UNITED STATES PATENT AND TRADEMARK OFFICE

Office Action Summary

10/757,949

LEHMANN, ROLF

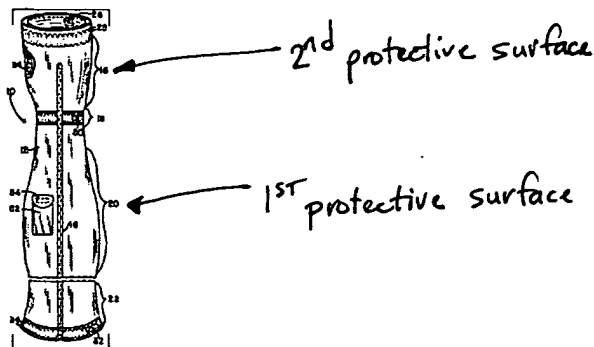
Santa Cruz et al. discloses a glove with a sleeve 10 wherein the sleeve has a first protective surface 20 for protecting the lower arm/wrist (see figure below).

With regard to claim 2, the glove is designed with a second protective surface 16 in the form of a salient bracket for the back of the hand.

With regard to claim 3, the second protective surface 16 extends as far as the area of one or both sides of the hands.

With regard to claim 4, the second protective surface 16 extends as far as the area of the finger ends.

With regard to claims 5/1, 5/2 and 5/3, the first 20 and second 16 protective surface is detachably secured to the glove (Col. 3, lines 12-29).

With regard to claims 10/1, 10/2 and 10/3, the first protective surface 20 and the second protective surface 16 is secured to the glove 10 via elements 24, 32 and zipper 46.

With regard to claims 11/1, 11/2 and 11/3, the first protective surface 20 has at least one fixing means 32 for adjustment to the contour of the lower arm.

With regard to claims 12/11/1, 12/11/2 and 12/11/3, the fixing means is an elastic strap 32.

With regard to claims 13/1, 13/2 and 13/3, the width of the first protective surface 20 is such that the lower arm is completely covered by the first protective surface 20 and the length of the first protective surface 20 corresponds to at least half the length of the lower arm.

With regard to claims 14/1, 14/2 and 14/3, the second protective surface 16 corresponds to roughly the surface of the back of the hand.
